IEEE P802.11

Wireless Access Method and Physical Layer Specification

How Far Should an ESS Extend?

Michael Fischer
Digital Ocean, Inc.
4242-3 Medical Drive
San Antonio, TX 78229
Telephone: +1-210-614-4096
Facsimile: +1-210-614-8192
email: mfischer@CHILD.com

Figure 1. Encapsulated Information Element Format and Values for Type 2 Ethernet

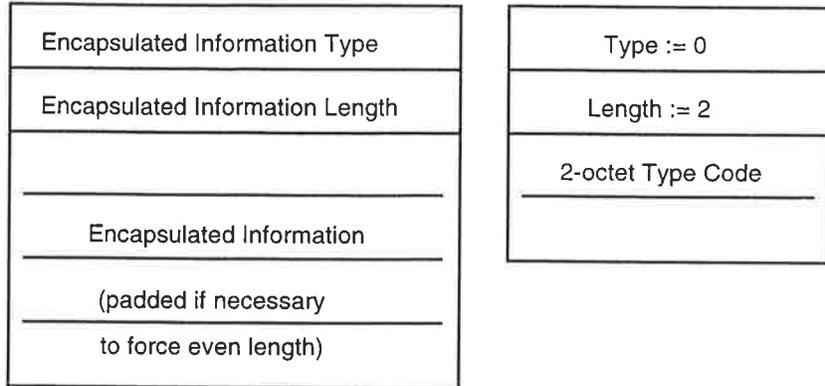
A general solution to this problem is to use the high-order bit of the subtype field of the data frame type. This bit is =0 for all eight currently defined data subtypes. Under this proposal, this bit being =1 would indicate the presence of encapsulated LLC information in the MSDU payload. The three low-order bits of the subtype field would be interpreted as currently defined, independent of the state of the high-order subtype bit. This permits MSDUs with encapsulated LLC information to be transferred in an identical manner to normal MSDUs, using either distributed or point coordination functions. When this high-order data subtype bit is =1, the MSDU payload begins with an element that encapsulates the ancillary LLC information. When present, encapsulated information element is located just before the conventional LPDU, and is considered part of the MSDU payload. Therefore, if WEP is used on a frame with ancillary LLC information, the IV field is located between the MAC header and the encapsulated information element.

The general format of the encapsulated information element, and the specific layout and values for use with type 2 Ethernet, are shown below in Figure 1. The first octet contains a type code indicating the type of encapsulated information. Currently a information type value of 0 is defined to mean a protocol type code, and all other type values are reserved. The second octet contains the number of octets in the remainder of the element, which is always an even number. If necessary, a pad octet is added at the end of the encapsulated information to maintain even octet alignment for the remainder of the MSDU payload. For information type 0, the information length is 2.

1. A portal which integrates an ill-behaved, non-802 LAN (a LAN that puts LLC-visible information in its MAC header) shall generate an encapsulated information element to hold this information as a part of the MSDU payload of each frame distributed within the ESS after receipt from the integrated LAN. The resulting MSDUs shall be sent using data subtypes in the range 8-15. When such a portal receives a frame containing an encapsulated information element from within the ESS, the encapsulated information shall be used to generate the appropriate field(s) of the integrated LAN frame, as indicated by the type of the encapsulated information element.

2. A portal which integrates a conventional, 802-type LAN shall discard encapsulated information elements on MSDUs received from the within the ESS unless there is a generally-accepted method of handling the particular type of ancillary information indicated by the encapsulated information element type over the 802-type LAN integrated by this portal.

3. All stations of an ESS involved in the inter-station transfer of frames for distribution services (e.g. APs and stations that are part of a WDS) shall forward all MSDUs as appropriate for their addressing information, leaving any encapsulated information elements intact.

4. All other stations, upon valid reception of an MSDU containing an encapsulated information element, may either discard the encapsulated information, or may report that information to the local LLC entity as status information, not as part of the MSDU payload. (The suggested manner of reporting is to use the "reception_status" parameter of the MA-UNITDATA.indication.) These stations are not required to be able to generate encapsulated information elements; however, these stations may generate MSDUs with encapsulated information elements if their implementation provides a means for the LLC entity to request such generation and to provide the information to be encapsulated.
